PLANNING COMMISSION AGENDA

December 16, 2010

29. **SDR-40146 - SITE DEVELOPMENT PLAN REVIEW - PUBLIC HEARING - APPLICANT: THE SMITH CENTER - OWNER: CITY OF LAS VEGAS** - Request for a Major Amendment to a previously approved Site Development Plan Review (SDR-26709) FOR A PROPOSED FIVE-LEVEL, 335-SPACE PARKING GARAGE WITH WAIVERS OF THE SYMPHONY PARK PARKING STRUCTURE DESIGN STANDARDS, BUILD-TO LINE STANDARD, REQUIRED RETAIL FRONTAGE STANDARD AND STREETSCAPE STANDARDS on a portion of 5.10 acres at the northeast corner of Clark Avenue and Promenade Place (APN 139-33-610-026), PD (Planned Development) Zone, Ward 5 (Barlow). Staff recommends DENIAL.

SHEET NO.
L6.01

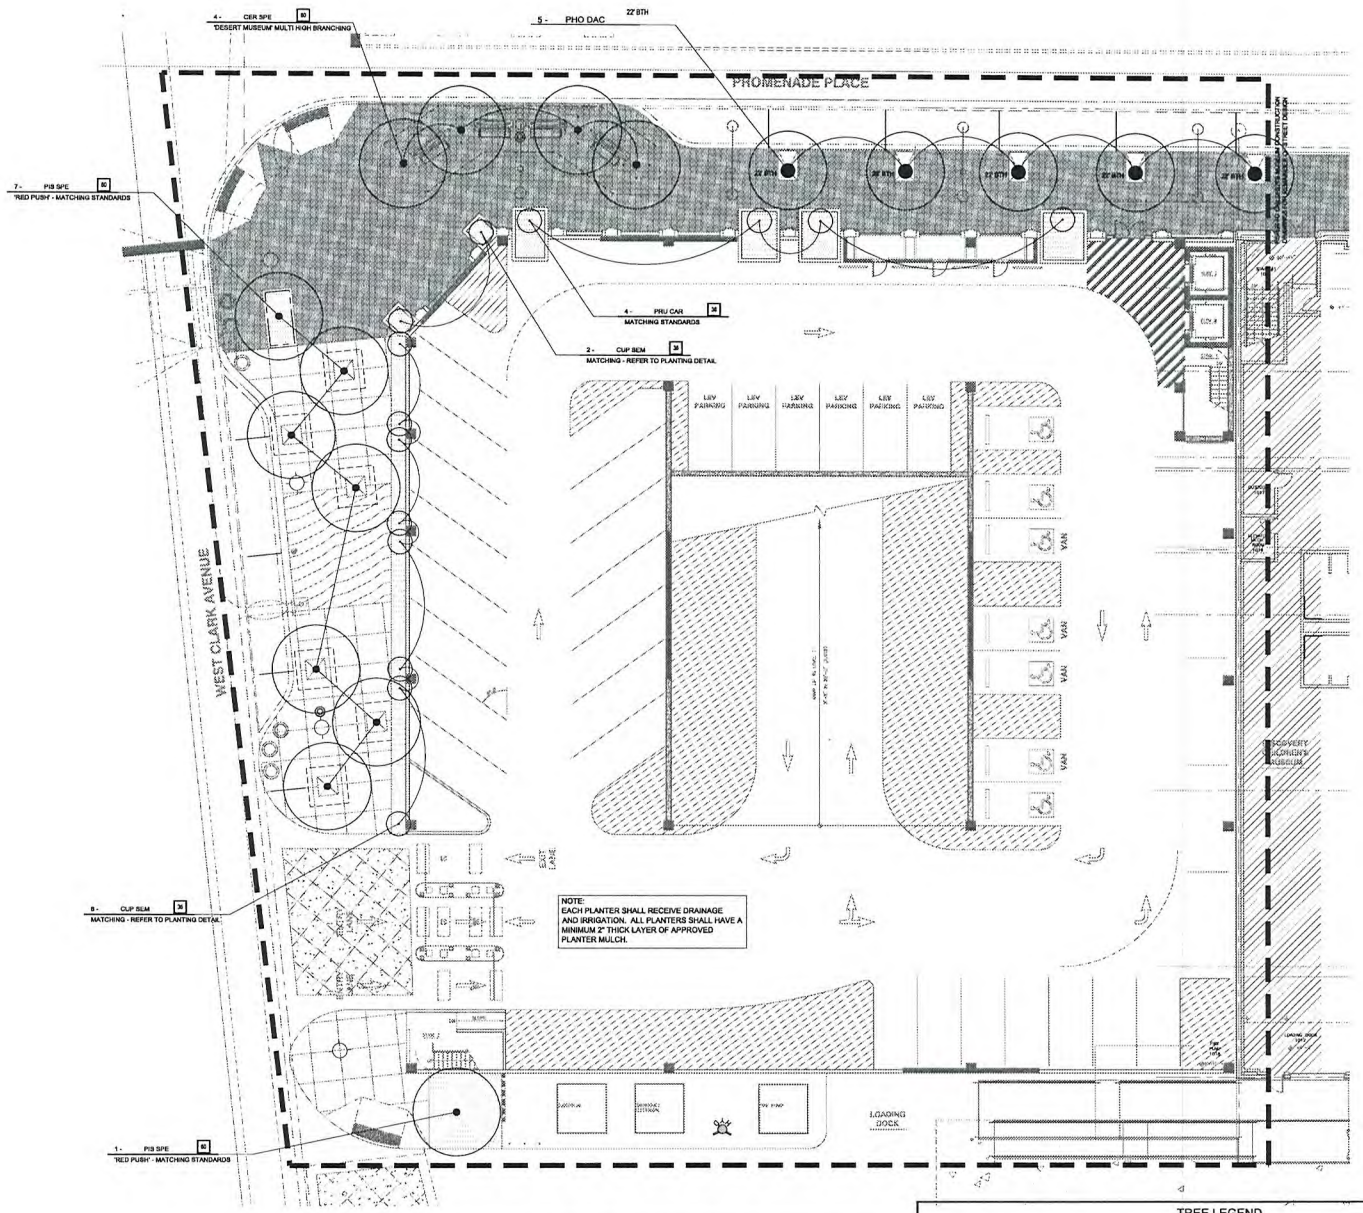
6. Sheet L6.01 – The tree legend needs to be modified to indicate all trees are to be "60 inch box" per the Design Standards, Section 2.1.5, and have a minimum of 6 feet clear to branching. The Prunus Caroliniana is not approved. The Italian Cypress is approved subject to the conditions stated above in 3 a., however, it should be noted it is not desert theme appropriate and is being approved only to allow some vertical plant treatment on the West Clark elevation of the building.

SHEET NO.
L7.01

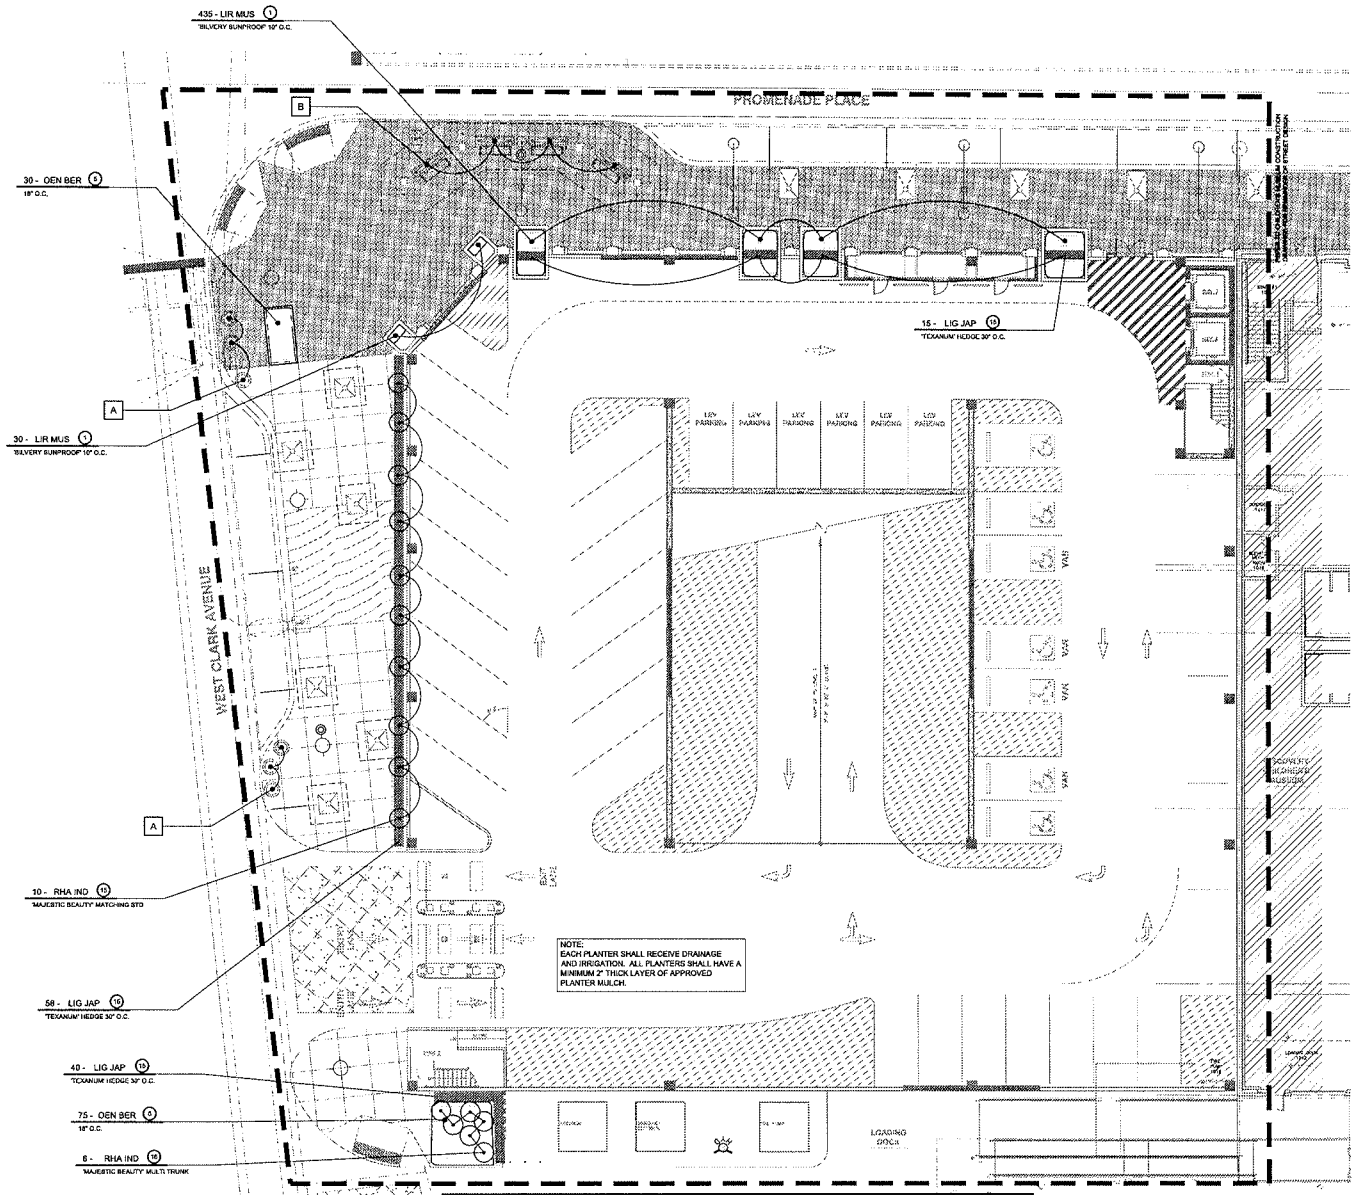
7. Sheet L7.01 – The shrub legend needs to be modified. Horse Tail not allowed (high water use), use Dwarf Rosemary instead. Privet not allowed. Lily Turf not allowed. Indian Hawthorn not allowed (moderate to high water use). The legend is missing Desert Spoon, Red Yucca, and Desert Carpet Acacia from the approved plant pallet.

SHEET NO.
GA2.01

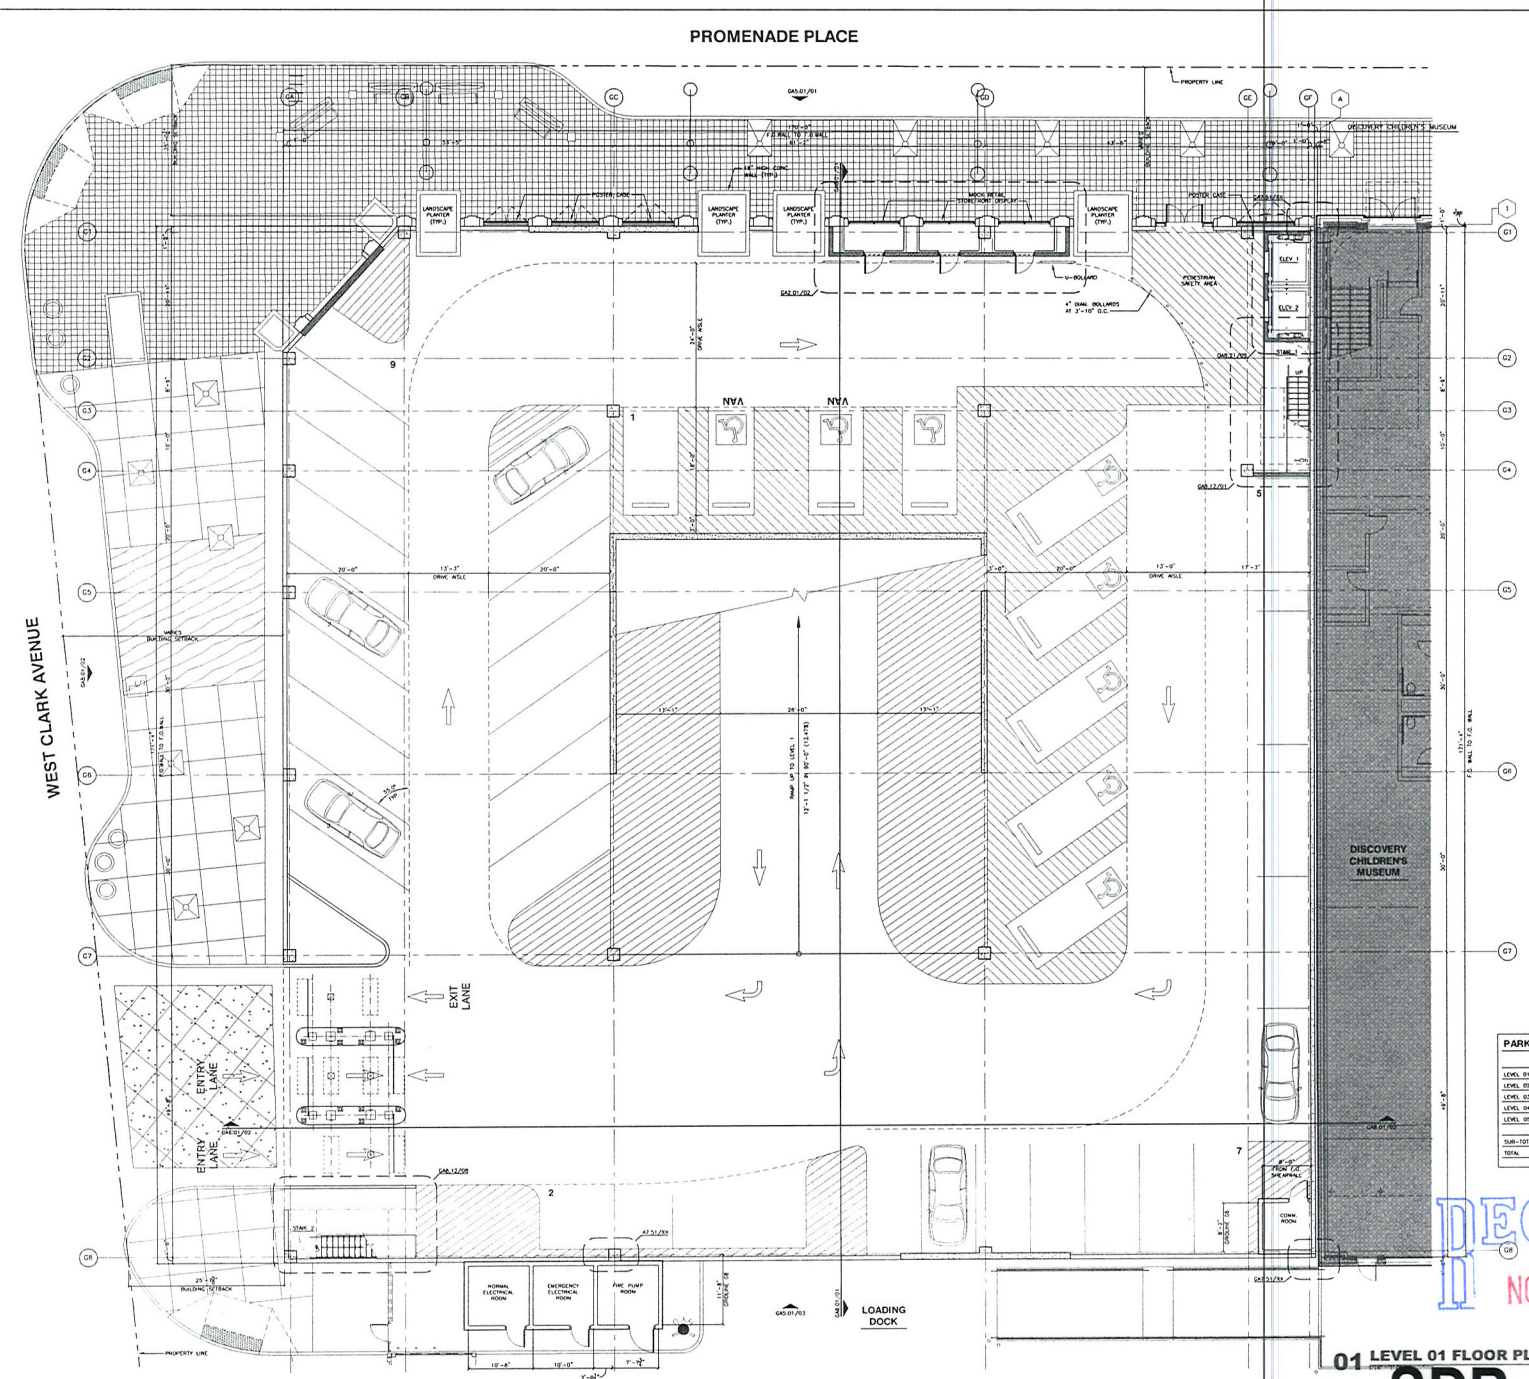
1. Sheet GA2.01- the circulation of the ground level shown in the revised garage is confusing and creates conflict points for patrons. Please modify. Also the planters shown on the Promenade Place sidewalk extend too far into the sidewalk and reduce the pedestrian space well below the 10 foot minimum required. Please reduce the size of the planters to the build-to-line.

SHEET NO
GA5.01

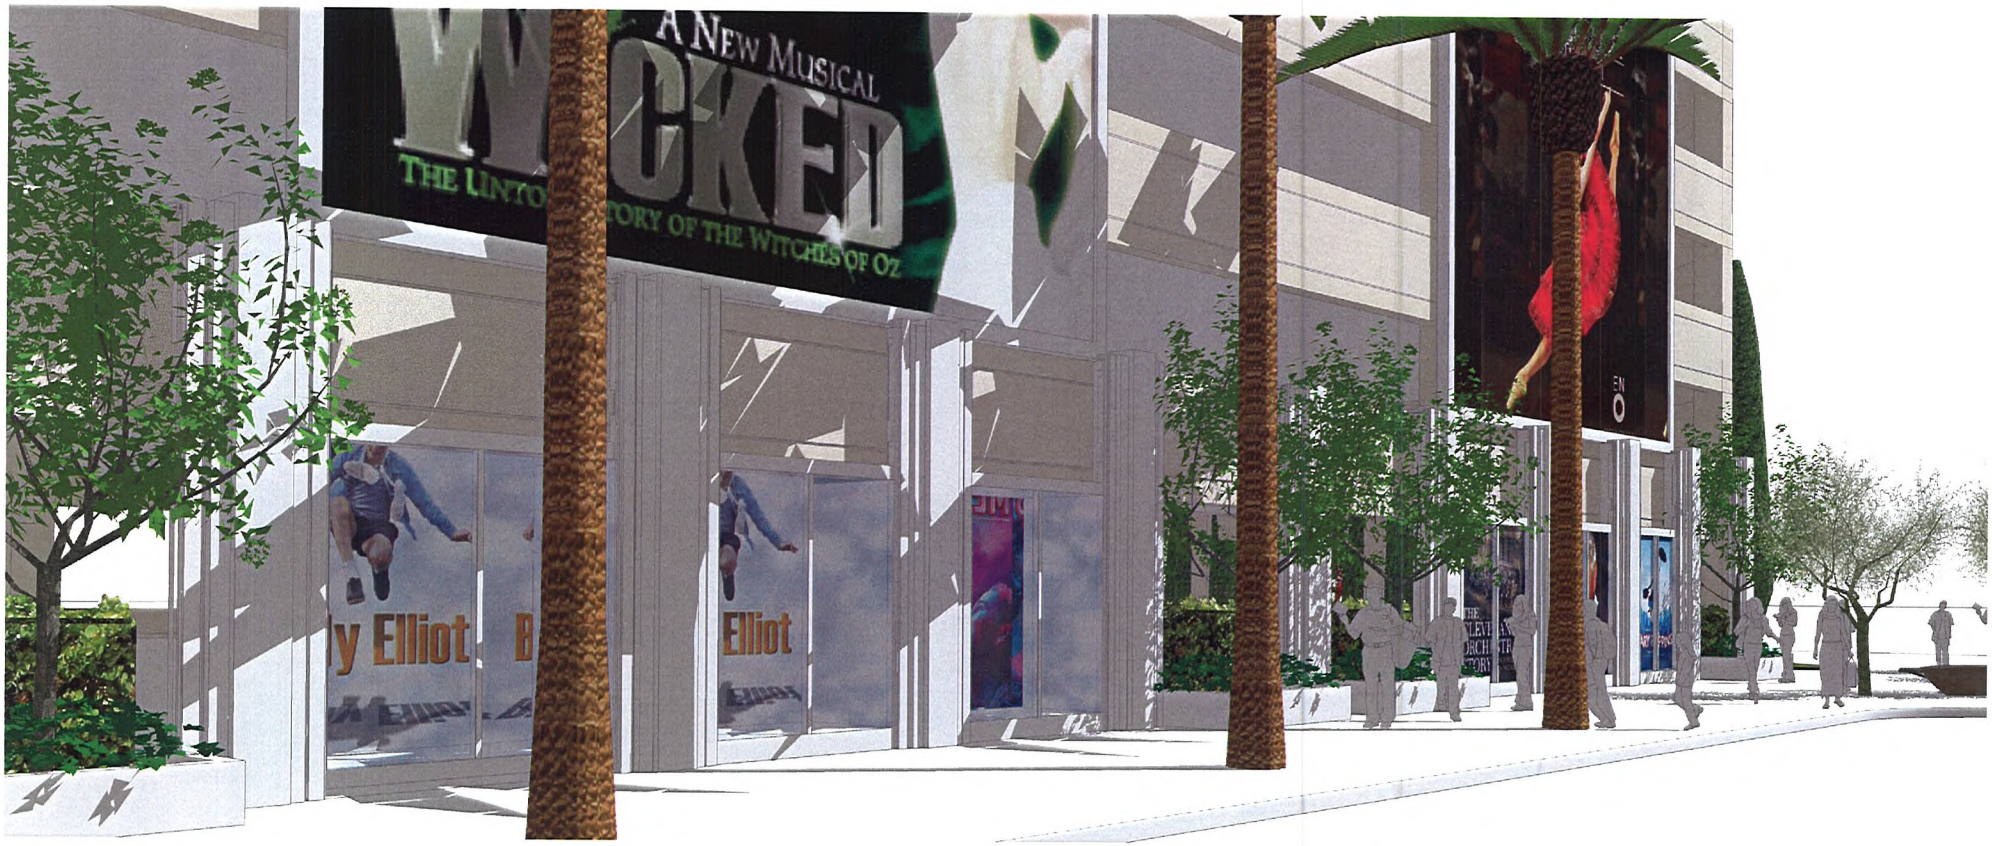
1. The Garage elevations shown on Sheet GA5.01do not reflect any of the last set of comments from the SP-DRC and are found to be lacking the quality of architecture required for them to be approved per the Design Standards. If approved anyway, the following Sections of the Required Design Standards would have to be waived, presented here with a parenthetical note of how the current project responds.

2. Sheet GA5.01
   a. Provide canopies along the rest of the Promenade Place elevation over the display openings.
   b. Provide an architectural treatment on the West Clark Avenue elevation similar to the Promenade Place elevation
